**RE: PROPOSED HORSLEY PARK INDUSTRIAL ESTATE  
PROJECT APPLICATIONS 10\_0129 AND 10\_0130**

**SUBMISSIONS / OBJECTIONS TO**  
**PROJECT APPLICATIONS 10\_0129 AND 10\_0130**  
**PROPOSED HORSLEY PARK INDUSTRIAL ESTATE**

**ATTACHMENT A - Report of Dr. Richard Lamb of 19 May 2011**

**Figure 3**

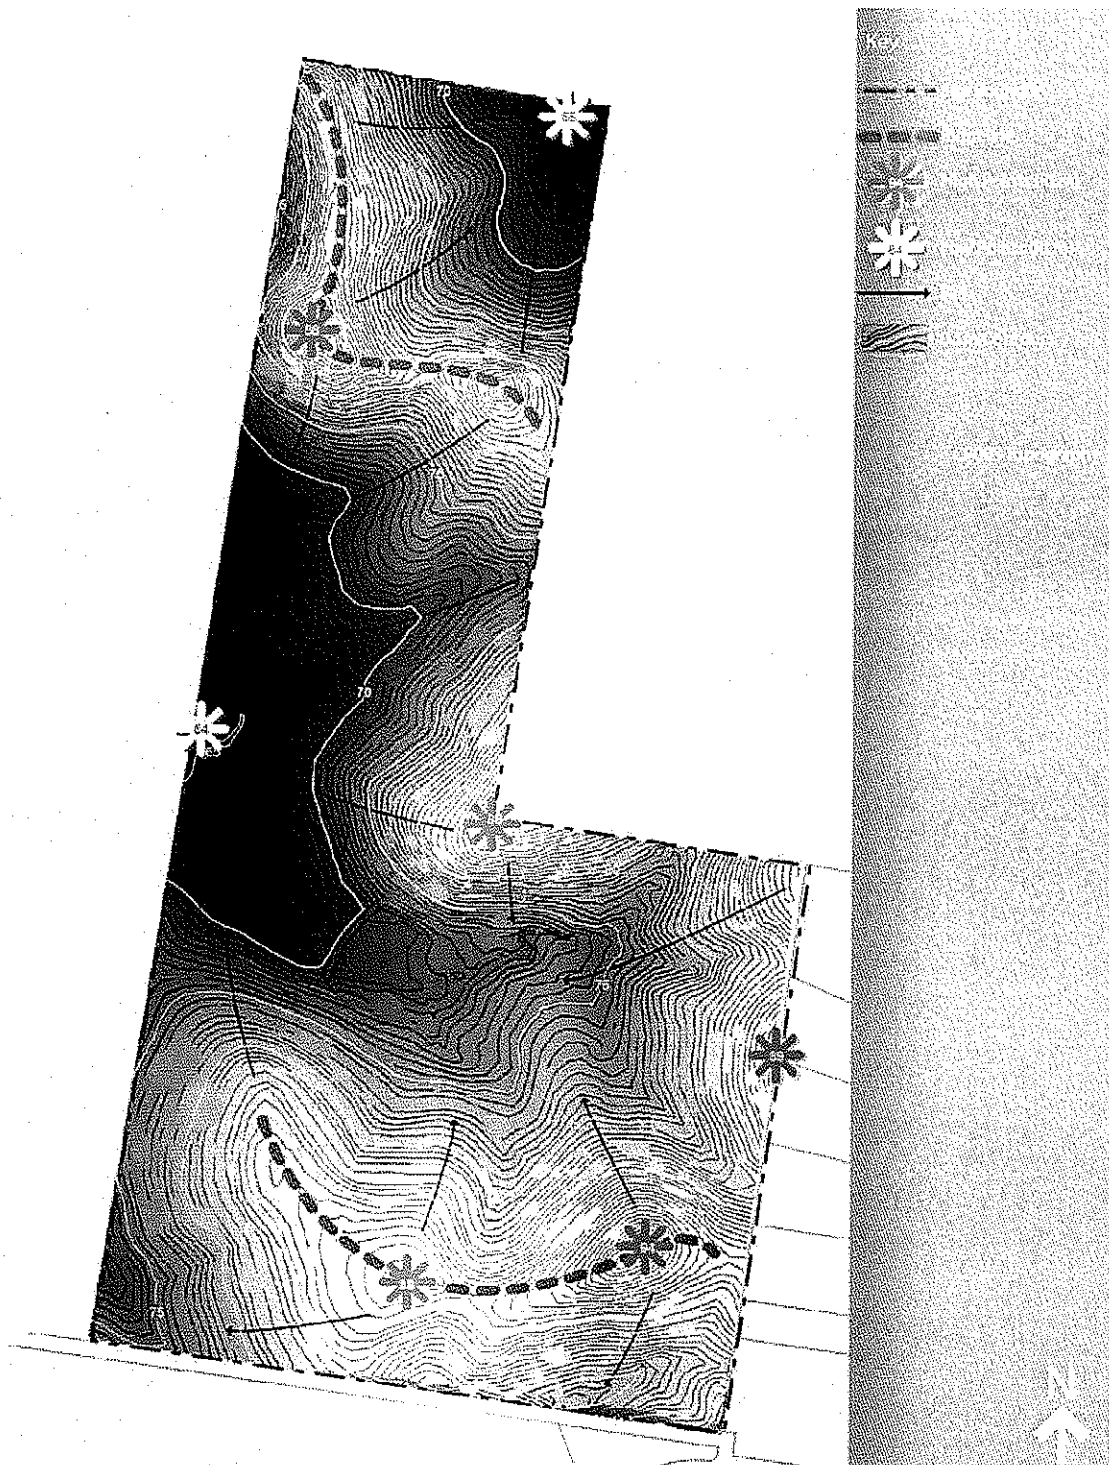
The report identifies the location of the highest point at the southeastern corner of the ridge at the site of a dwelling. The high point is at RL94metres. The site topography is as shown in figure 3 below.

**Figure 10**

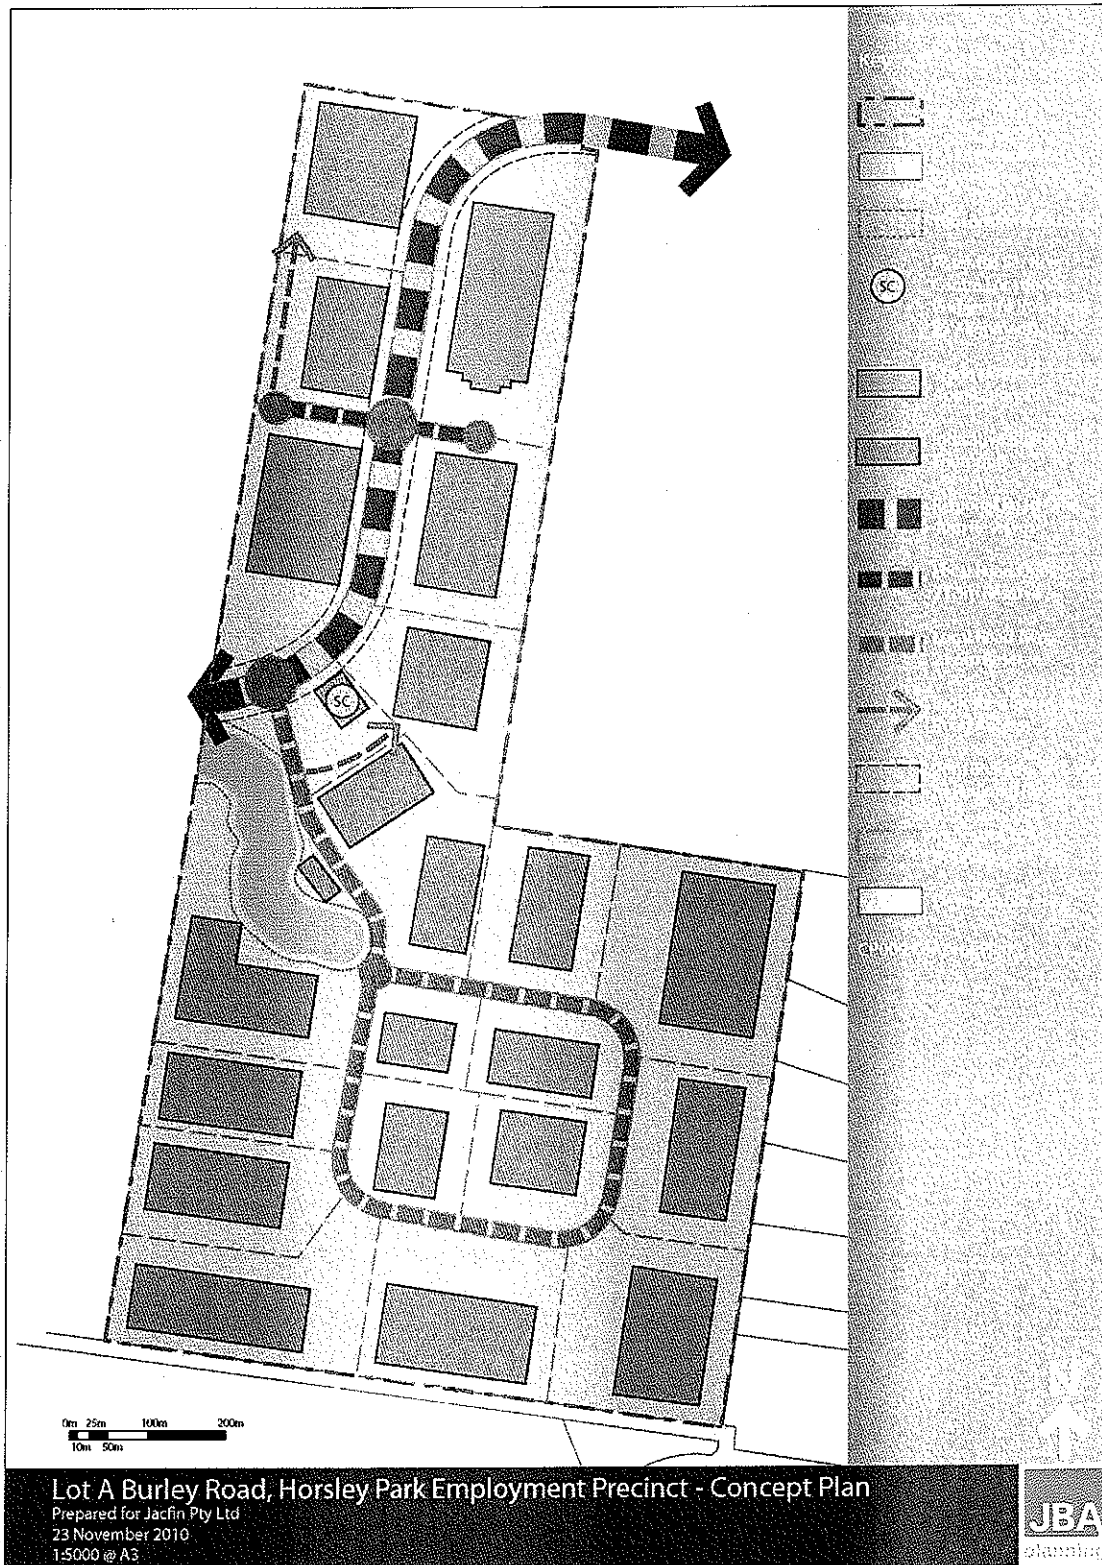
The proposed Concept Plan is shown in figure 10 below.

4.7 It is inconceivable that any objectively based environmental assessment would support the removal of a significant existing ridgeline and hillside to permit the construction of large warehouse facilities, given the particular characteristics of the rural landscape and the proximity of rural residential properties to the southeast and southern boundaries. A visual inspection of the hillside to the immediate rear of our property will readily determine the unreasonableness of the proposal to remove the existing hillside.

**VIEW 4 - EXISTING**

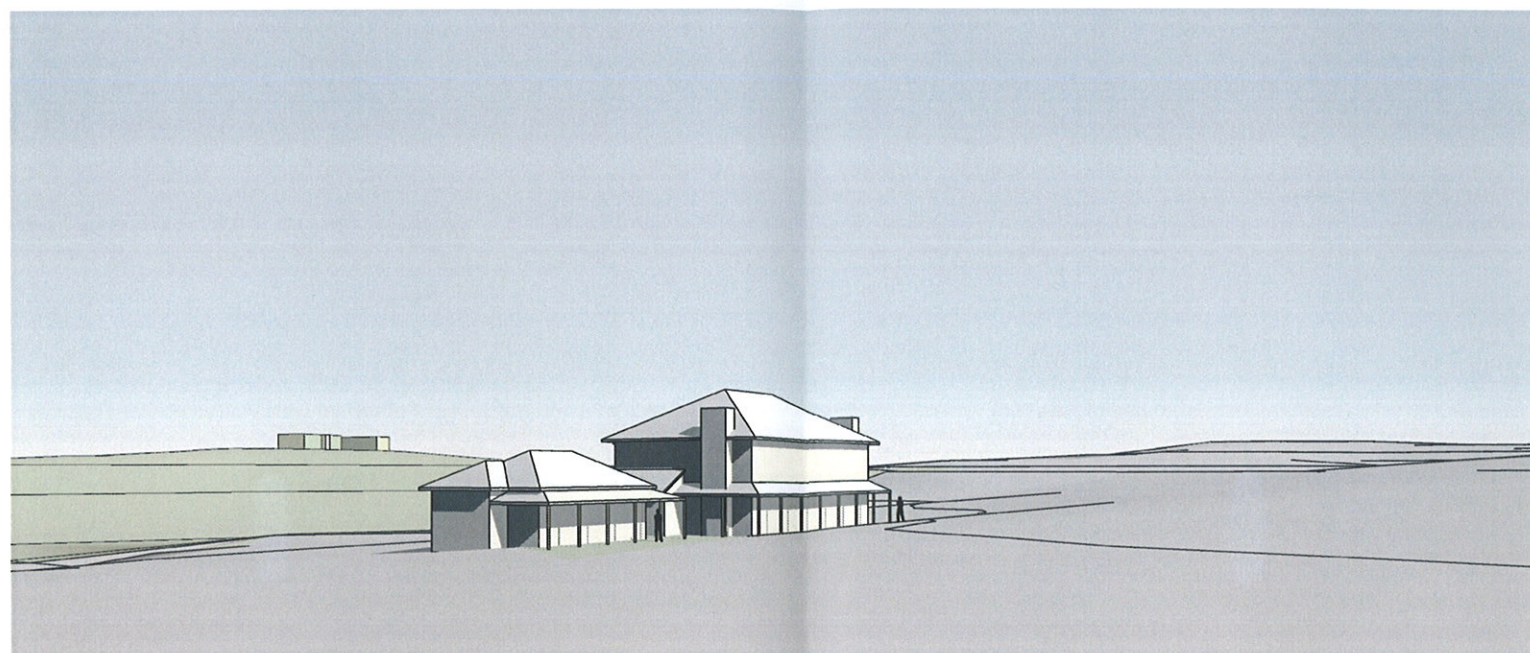
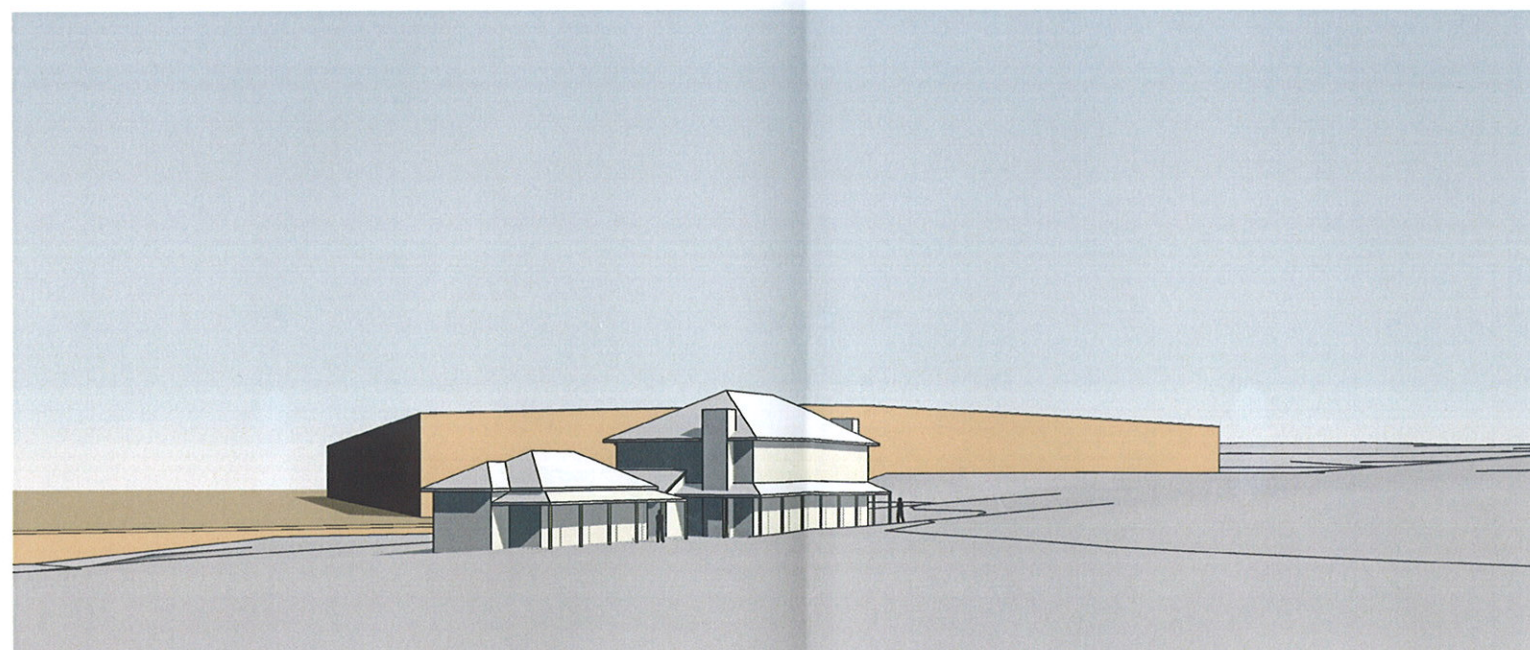
5.12 By way of illustration, I attach at pages 15 – 19 Visual Impact Diagrams drawn to scale by **Peter Morson**, an architect who has been retained on our behalf. These visually show the position and scale of the proposed building relative to our residence and the obvious severe visual impact:

The attached 3-D images give a useful impression of the relationship that is intended to exist between the proposed buildings and the Crestani residence. They confirm my assessment of the likely relative levels between the buildings and they also show the totally unrelated building scale and form that will exist between them.

SECTION - EXISTING

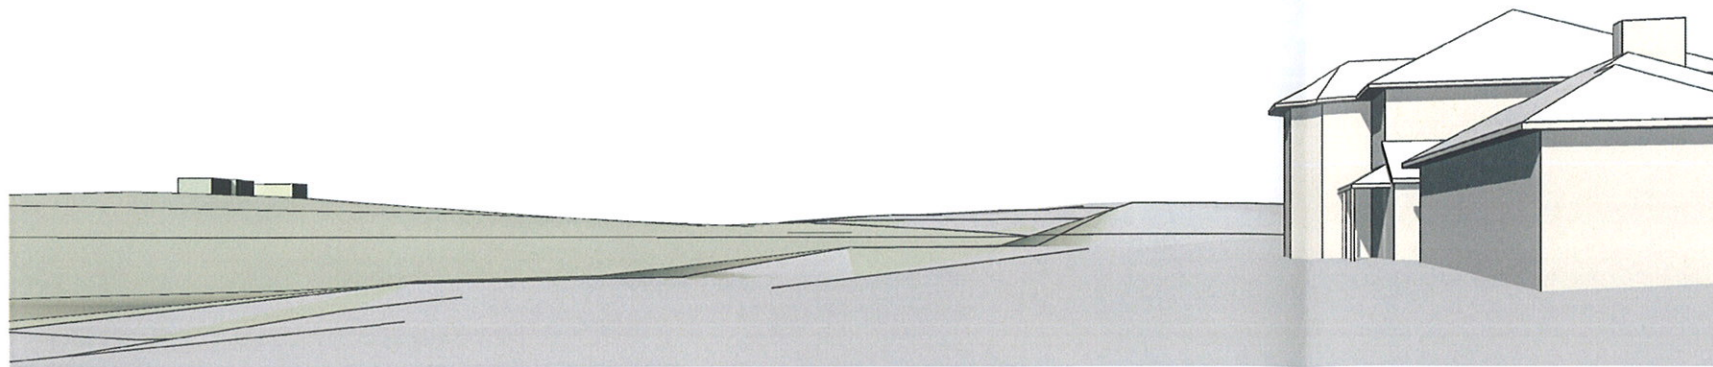
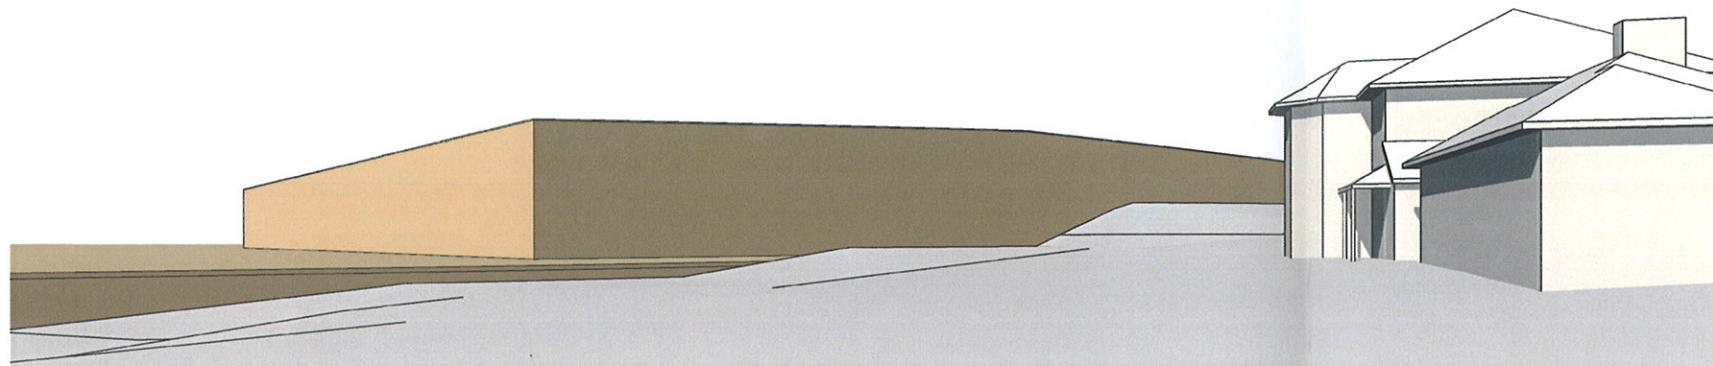
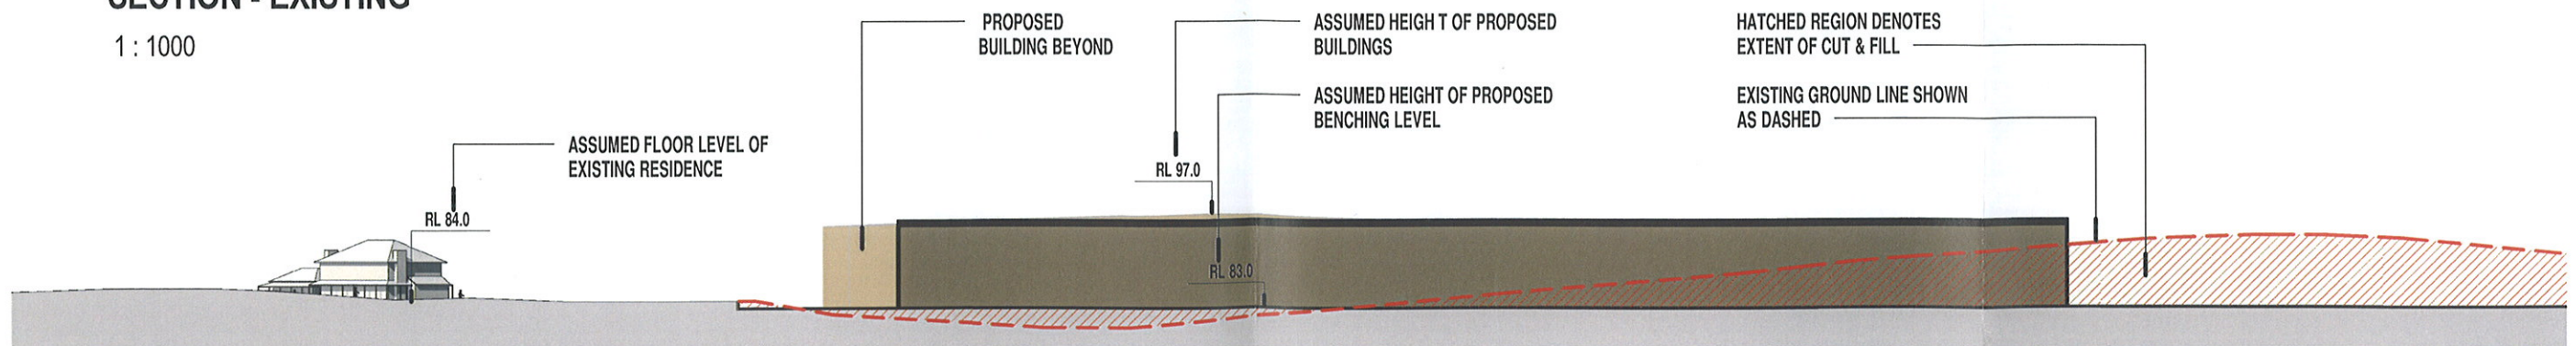
The sections on Drawing No. A04 are particularly useful in showing how the existing topography that provides the existing setting for views from the Crestani property is proposed to be totally removed and replaced by a flat plane on which are very large buildings close to the boundaries and which will clearly dominate the view and be incompatible with the form, scale, character and height of the adjacent buildings.
